I wish to submit my observations to An Bord Pleanála on the additional information and comments provided by Wexford County Council in relation to the construction of a mixed-use development at **Trinity Wharf, Trinity Street, Wexford, Co. Wexford –An Bord Pleanála Ref PL303726-19.**

This submission is made by **Katja Hayes, 1 Seaview Avenue, Wexford, Co. Wexford** – a resident in the immediate vicinity of the proposed development.

Image 2: Fisher's Row – on-street parking on Saturday, 16/11/2019

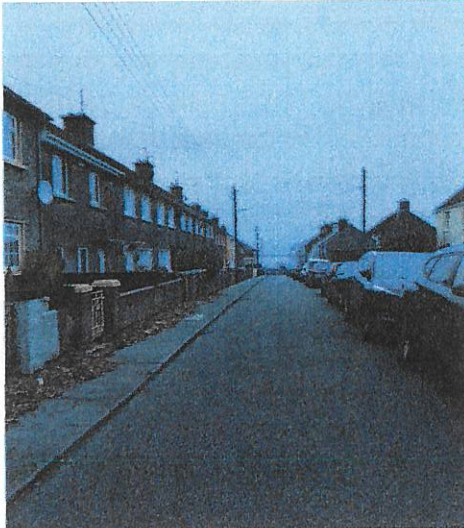
The stays of these visitors most likely fall within the maximum four hours allowance of pay and display parking on Trinity Street. With the removal of 18 existing parking spaces along Trinity Street and Seaview Avenue, the remaining spaces will not be enough to accommodate visitors and residents during the day and in the evenings (particularly before and during events) when on-street parking is free of charge. It seems to be assumed that residents do not require parking during the day and unlike stated by Wexford County Council, the adjacent streets of this part of Trinity Street (i.e. William Street Lower and Fisher's Row) do currently not provide enough parking spaces for residents within this area (i.e. elderly people and families with children) within a reasonable walking distance from their homes (as shown in the images below).

Furthermore, the pay and display model introduced on Trinity Street is currently only enforced on a very infrequent basis, as demonstrated by a business, car dealerships and car rental using on-street parking spaces within the pay and display area of Trinity Street on a daily basis for multiple vehicles associated with their businesses for more than four hours without any tickets being displayed.

Image 4: Wexford Town - The Faythe and Trinity Street area [Source: <https://wexford.maps.arcgis.com/home/webmap/viewer.html?useExisting=1>]

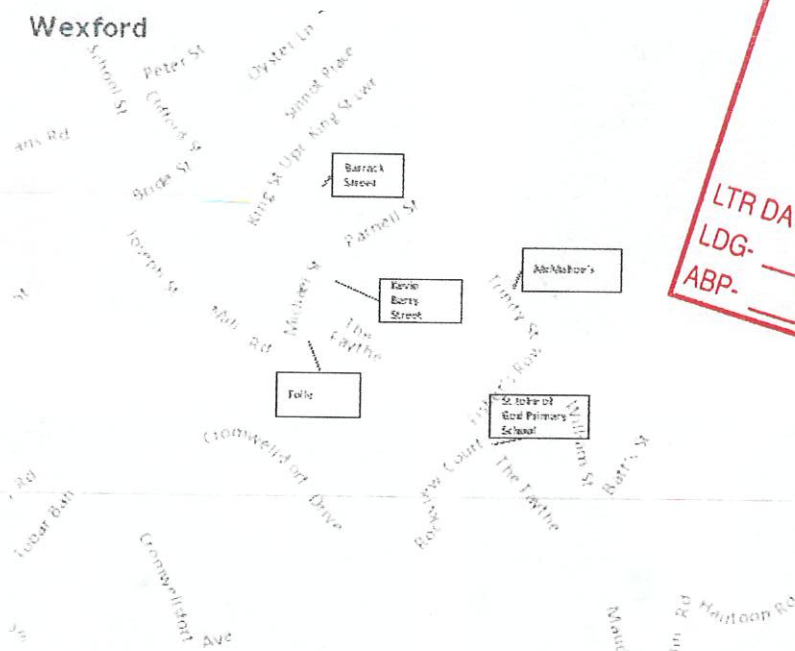
As mentioned on page 1, Wexford County Council proposes that delivery vehicles including HGVs approaching McMahon Building Supplies from the south will need to “circle the block” in order to approach the business from north due to proposed junction design and road markings. In practise and as shown on the map below, this would mean that HGVs and other delivery vehicles will have to either

- use the Faythe (entering at the beginning from William Street and passing by the local primary school or go up Fisher’s Row to turn right into the Faythe) → Kevin Barry Street → Parnell Street → Trinity Street
- turn into King Street Lower (at the Talbot Hotel) → Barrack Street → Parnell Street → Trinity Street
- turn into King Street Lower (at the Talbot Hotel) → King Street Upper → Mill Road → The Folly → Kevin Barry Street → Parnell Street → Trinity Street

Image 7: Fisher's Row

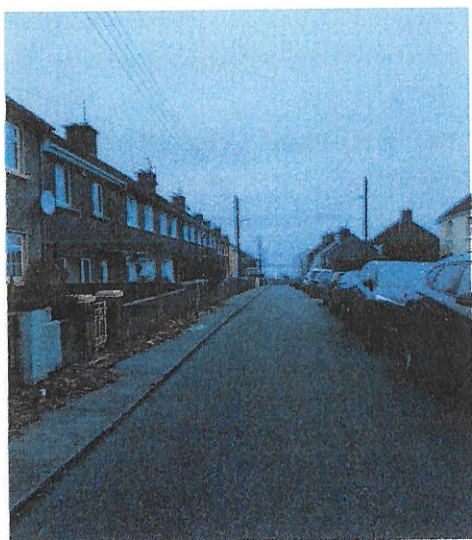
These options not only involve small and narrow streets in predominantly residential areas (as illustrated in the images below) but also mean that HGVs will be directed to pass by the local primary school. During school opening times (i.e. from 08:40 to the evening), over 200 primary school children are entering and exiting the school and at peak drop-off and pick-up times (i.e. from 08:40 to 09:00 and from 13:40 to 14:40), The Faythe is already suffering from heavy traffic congestion. Diverting HGVs through residential areas and by a primary school during opening hours seems to be against the common interest of road safety and seems to also transfer another issue arising from the proposed junction to an existing community and business. And as mentioned above,

Image 16: Suggested parallel parking in Seaview Avenue  
(Please note: not to scale as only for suggestive purposes)

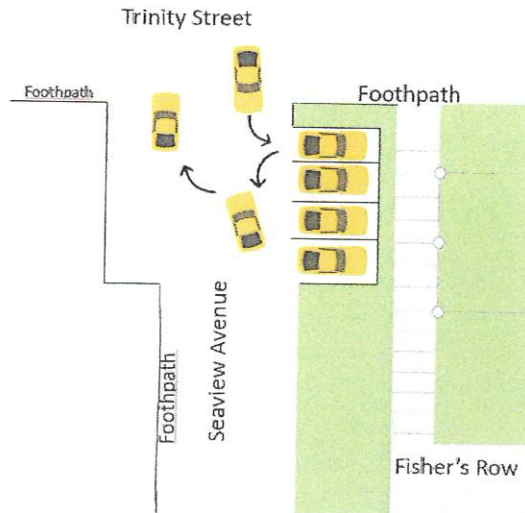
Furthermore, it is unclear why a turning head which is limited to passenger vehicles and small delivery vans is introduced in Seaview Avenue instead of providing, for example, four extra parking spaces for the residents of Seaview Avenue by extending the proposed turning head and converting it to a "residents only" parking space with parallel parking which will allow "turn-by-parking" as illustrated below:

Image 21: View from Seaview Avenue/Trinity Street/Fisher's Row

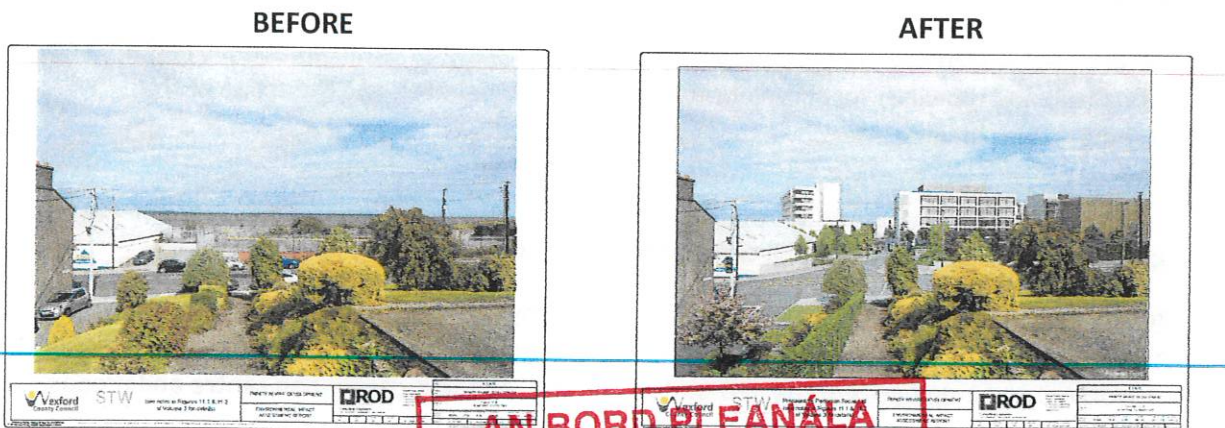
**KH Response:** Based on the graphical illustrations provided in the original application – available under [www.wexfordcoco.ie/sites/default/files/content/SpecialProjects/Trinity Wharf ABP/4.3%20Figures/Chapter%2011%20Figures.pdf](http://www.wexfordcoco.ie/sites/default/files/content/SpecialProjects/Trinity%20Wharf%20ABP/4.3%20Figures/Chapter%2011%20Figures.pdf) – the views of the development from Trinity Street, Fisher's Row and William Street cannot be considered "limited". As shown on the following images, the view of the the sea and Raven Point is completely replaced by a view of concrete and glass boxes:

Image 23: View from Fisher's Row/Trinity Street Junction

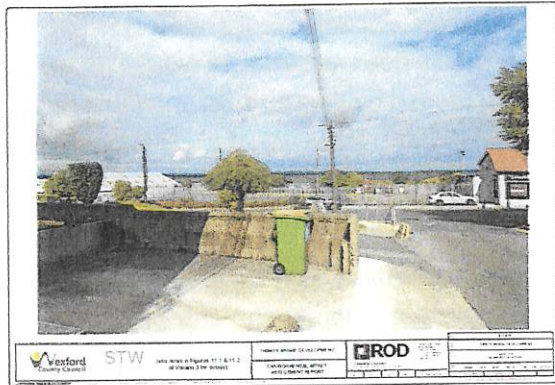
As per my previous submission, I am asking for the permission for five- and six-storey buildings to be refused.
